**Re: Case No. 21-4-EL-BGN**

In the Matter of the Application of Tymochtee Solar, LLC for a Certificate of Environmental Compatibility and Public Need to Construct a Solar-Powered Electric Generation Facility in Wyandot County, Ohio

**Third Supplement to Application – Facility Layout – Updated Figure 3-2**

**Reference:** Inverter Adjustment and Panel Removal

Figure 03-2. Facility Overview with Highlighted Adjustments

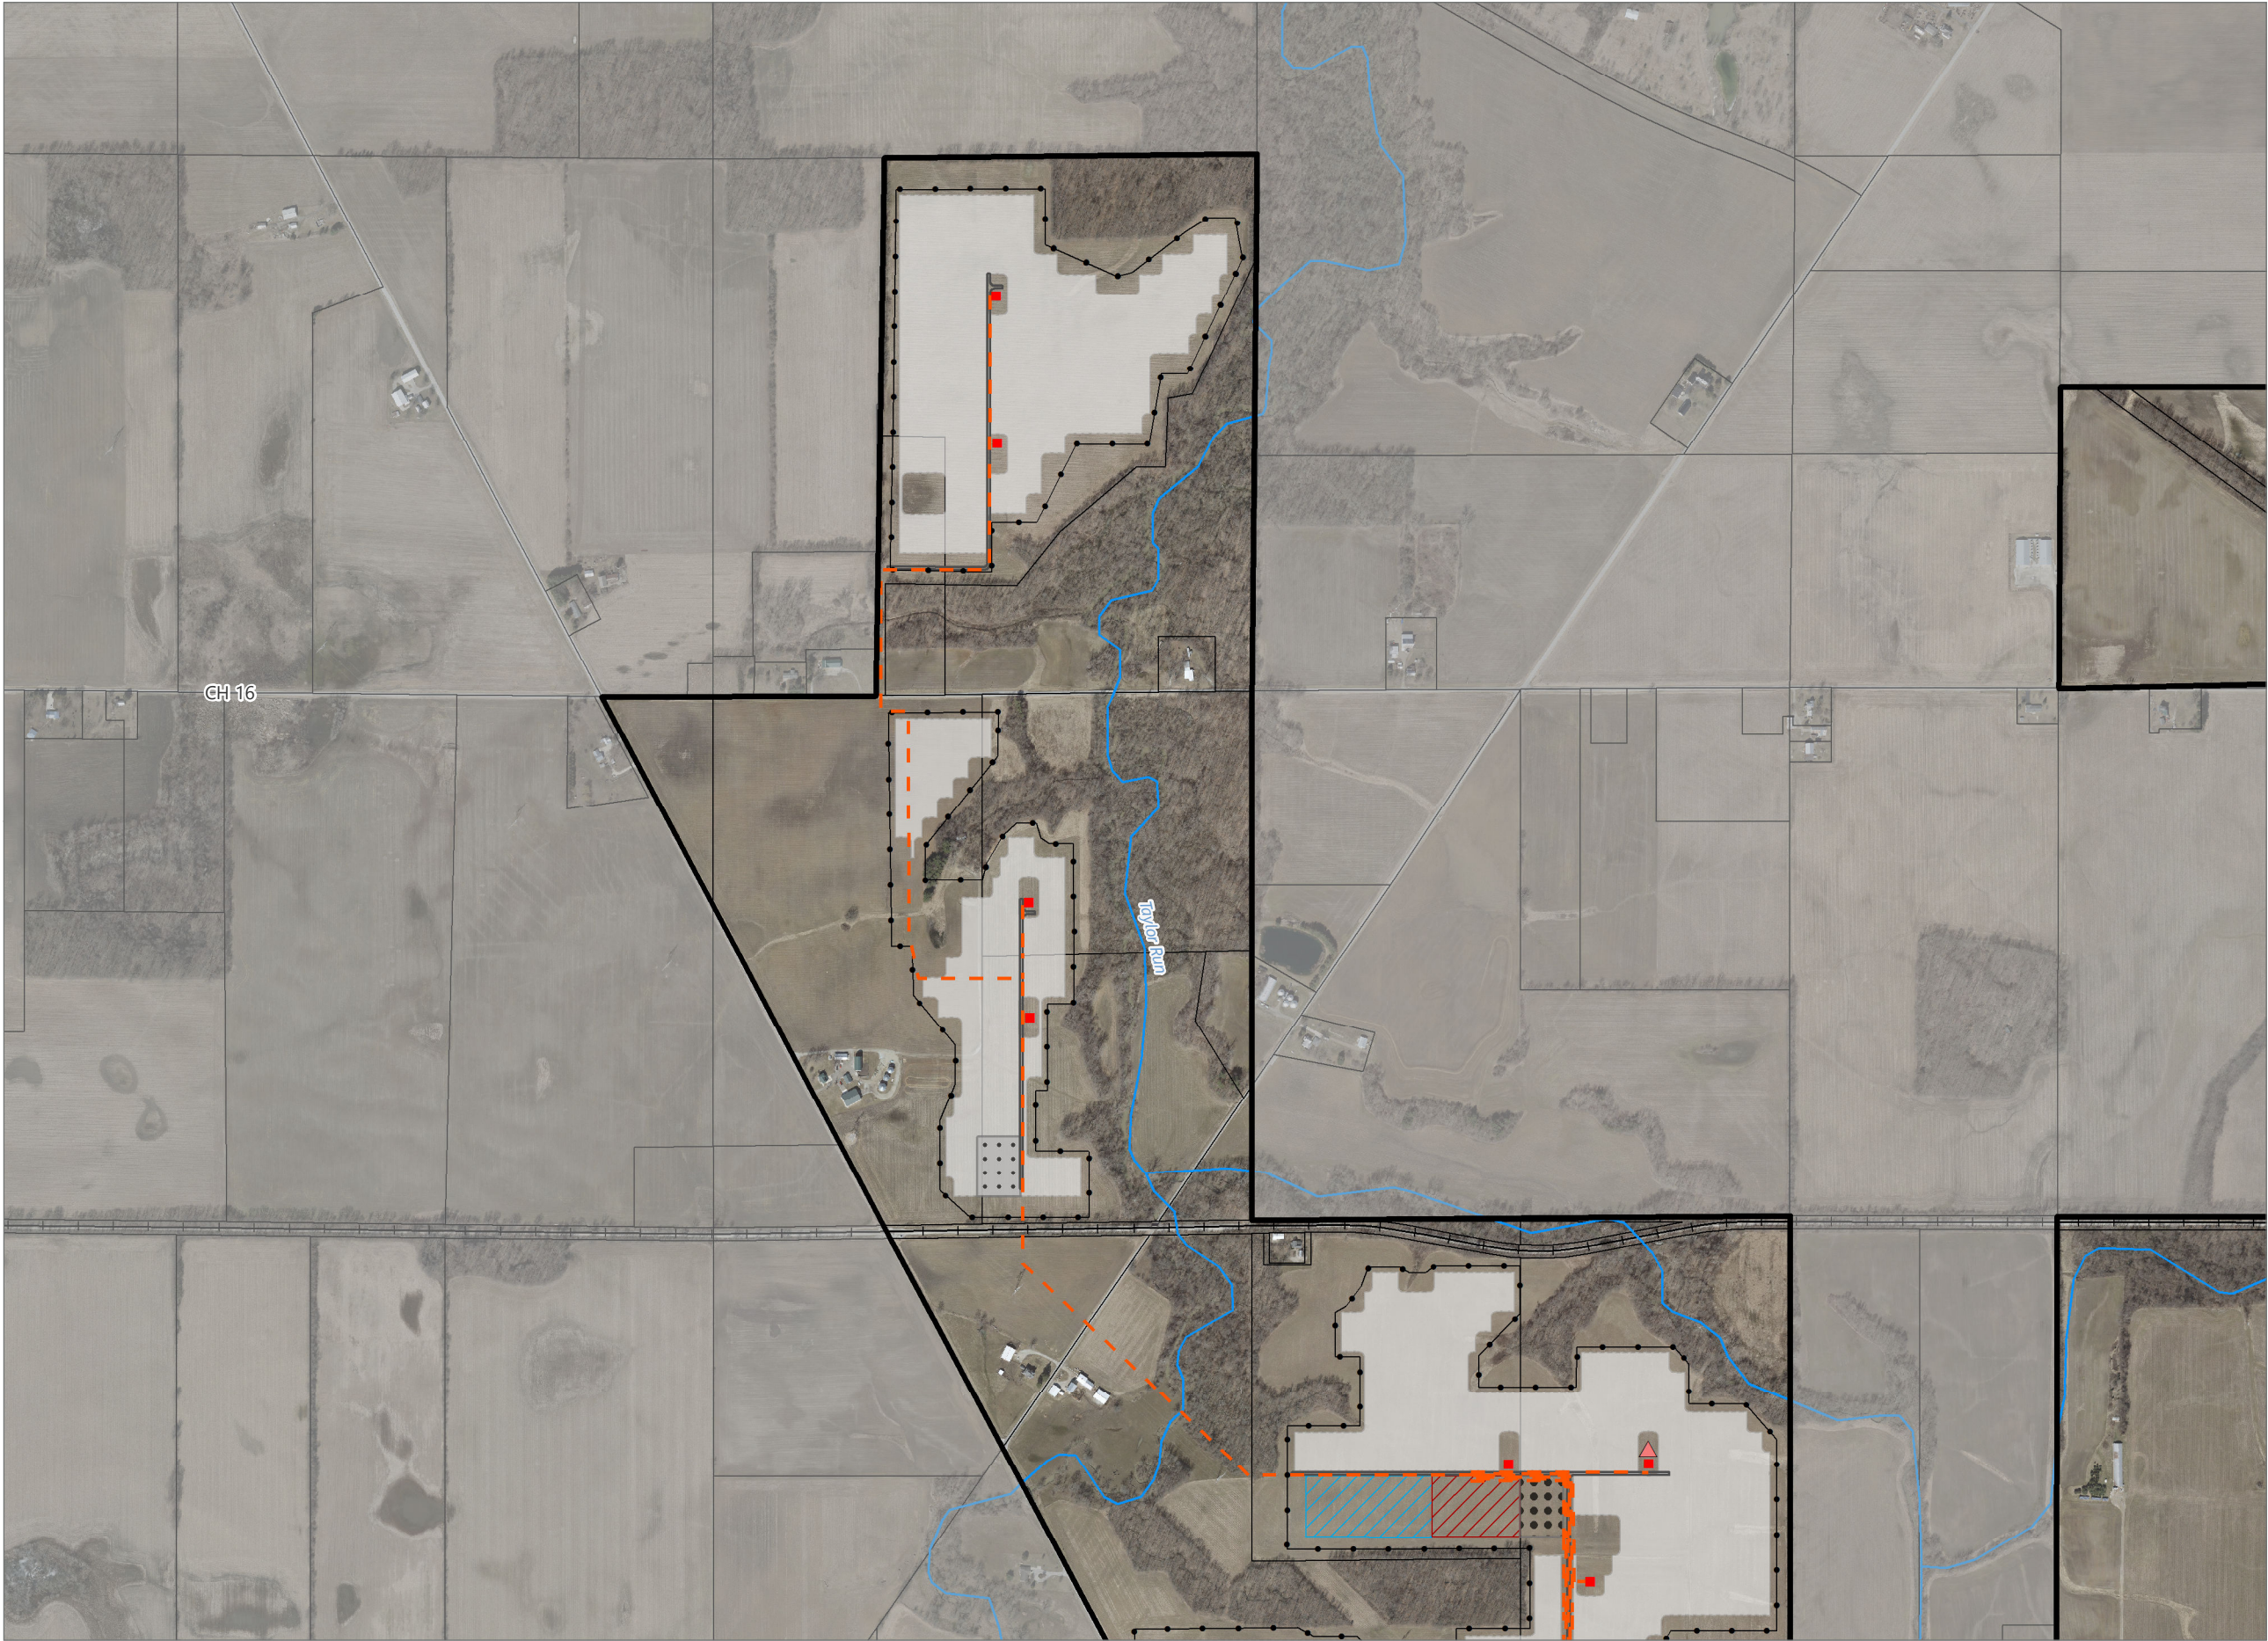
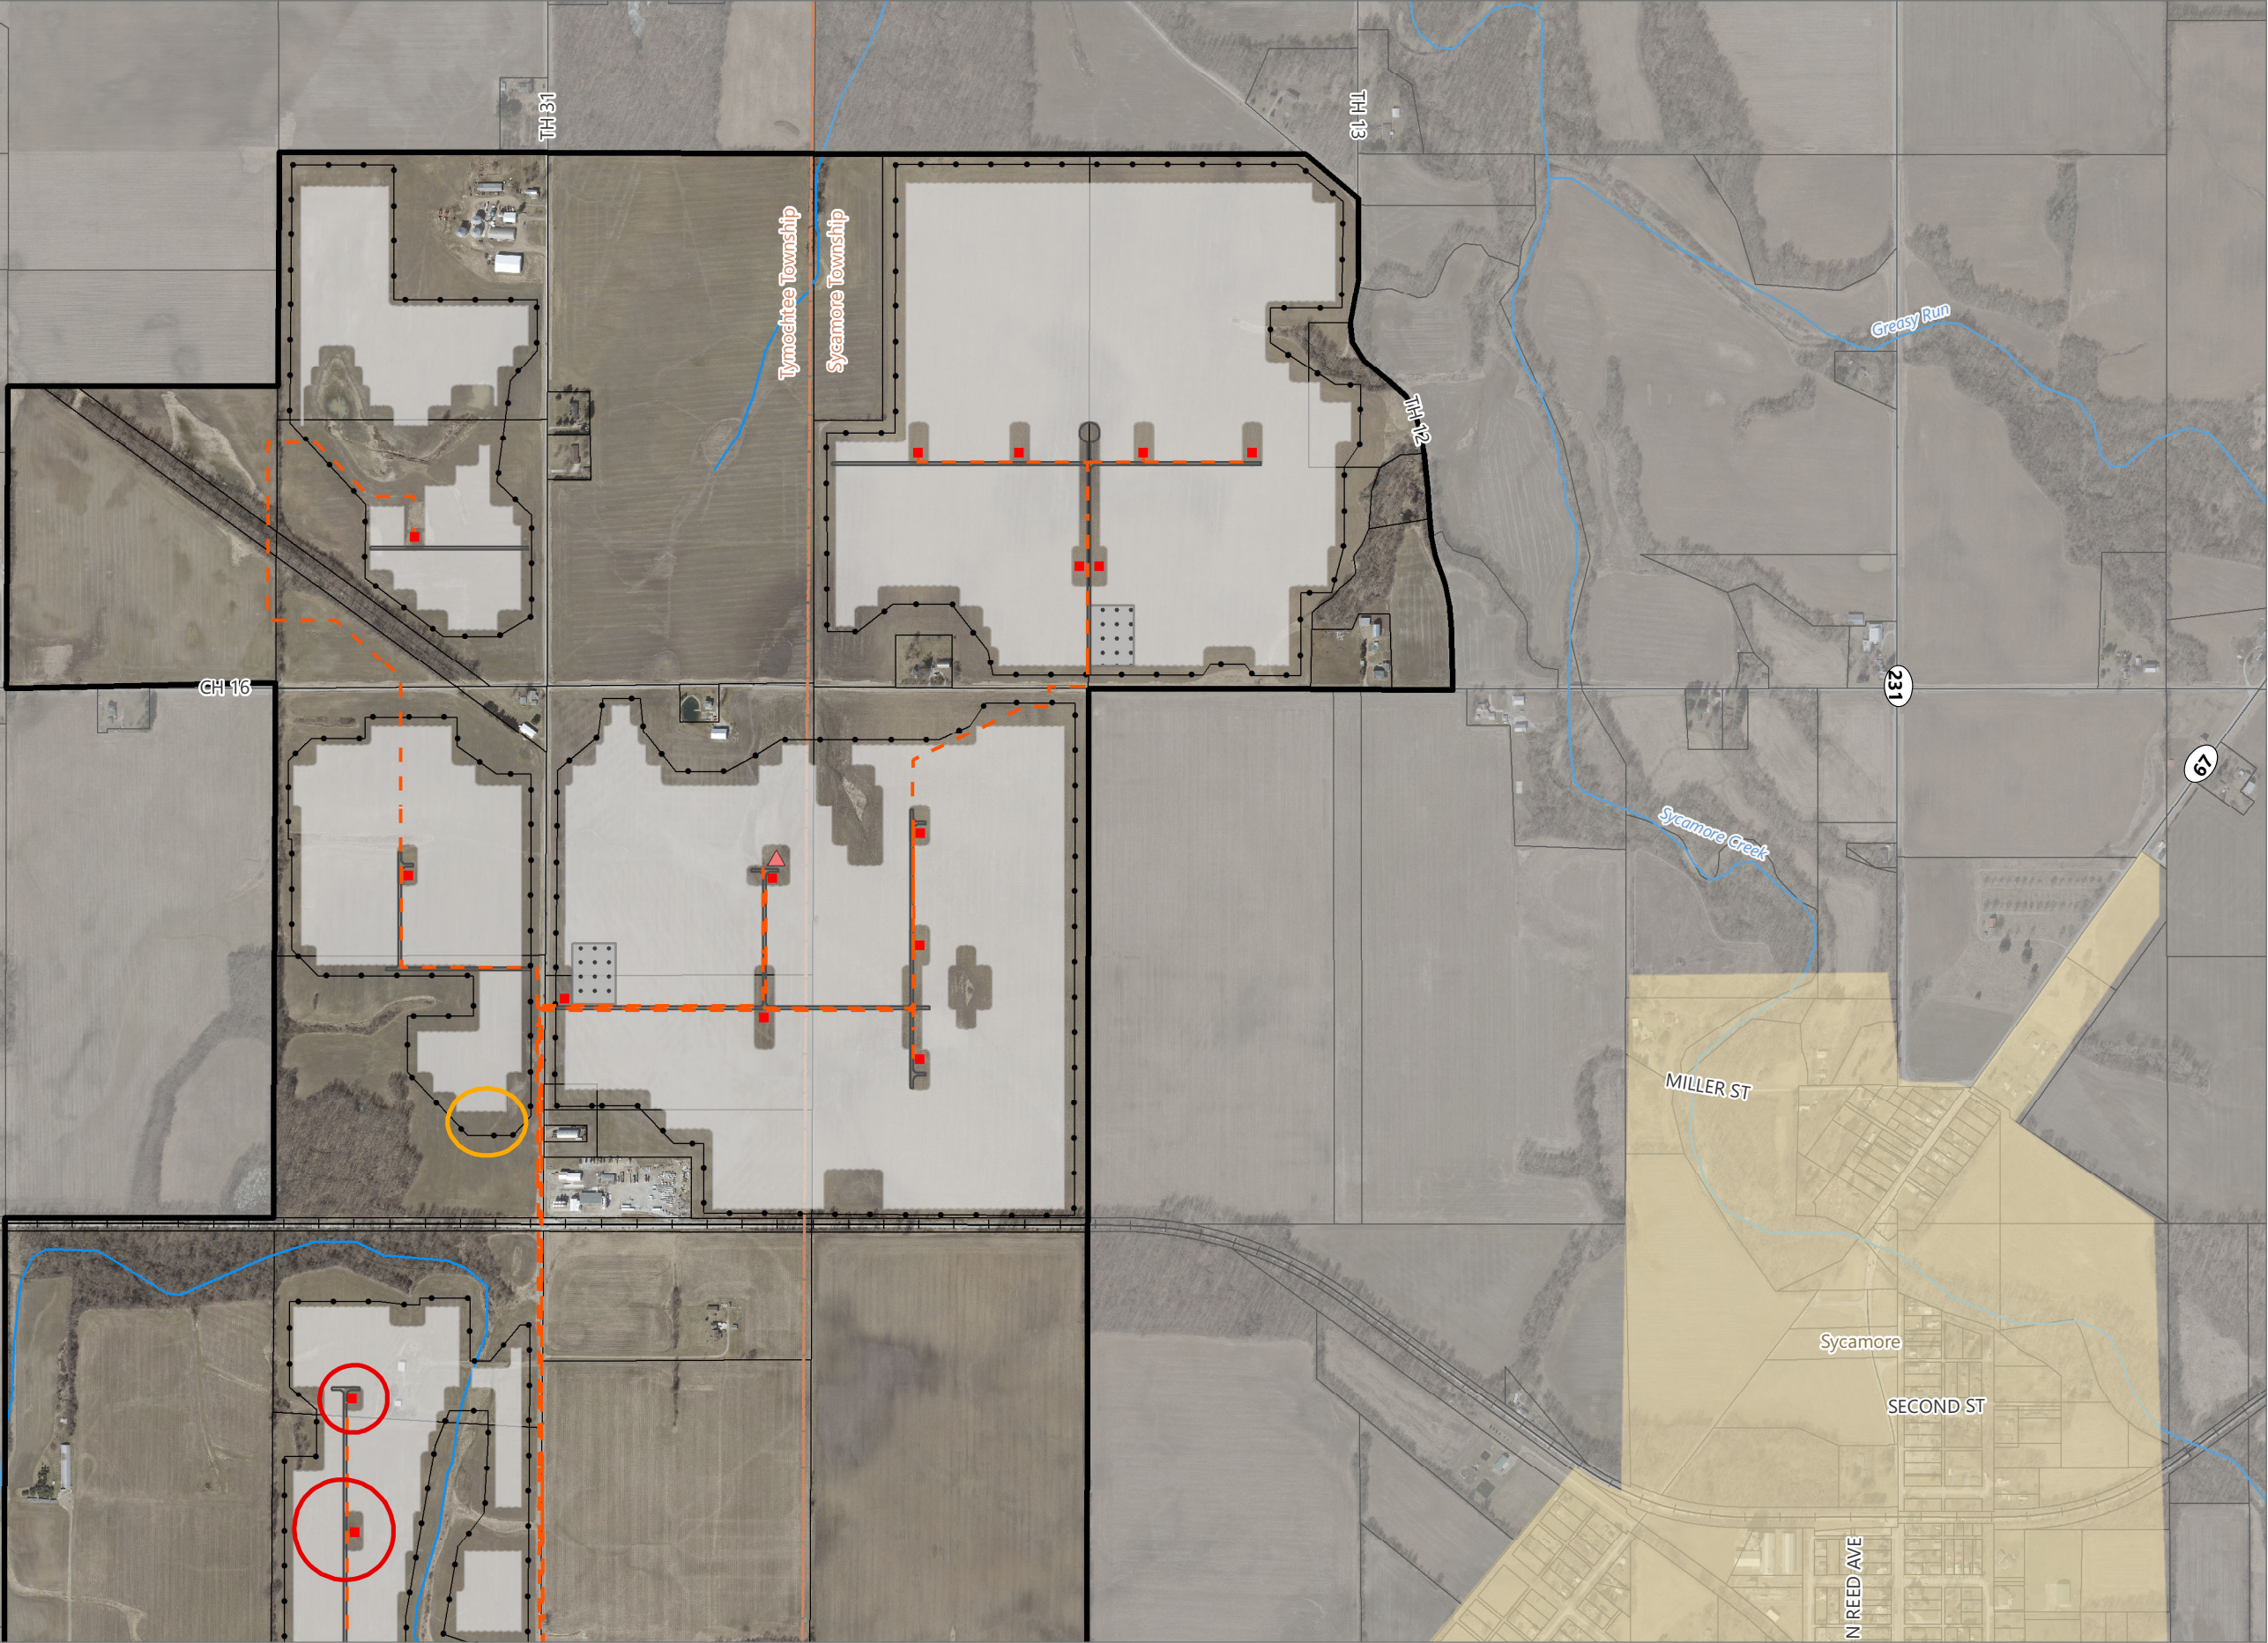
Tymochtee Solar has since reviewed this issue and has been able to make some minor adjustments to its planned facility layout. These adjustments were designed to resolve the potential noise concern while posing no additional adverse environmental impacts. The planned locations of two inverters have been shifted to increase their distance from the facility fenceline. These shifts also necessitated the removal of some planned panel areas for the placement of the inverters. Attached are two sets of Figure 3-2 that reflect these facility layout revisions. The first set of Figure 3-2 titled "Facility Overview with Highlighted Adjustments" shows the locations of these facility layout revisions on sheet 3. The second set of Figure 3-2 titled "Facility Overview" is a clean version of the Figure 3-2 and it supersedes and replaces Figure 3-2 that was filed with the Application on April 29, 2021.

Additionally, to address feedback from Ohio's State Historic Preservation Office, panel arrays were removed at two locations, which are shown on sheets 2 and 3 of the attached Figure 3-2 Facility Overview with Highlighted Adjustments map. These adjustments are also included on the attached Facility Overview clean version of the updated Figure 03-2 map.
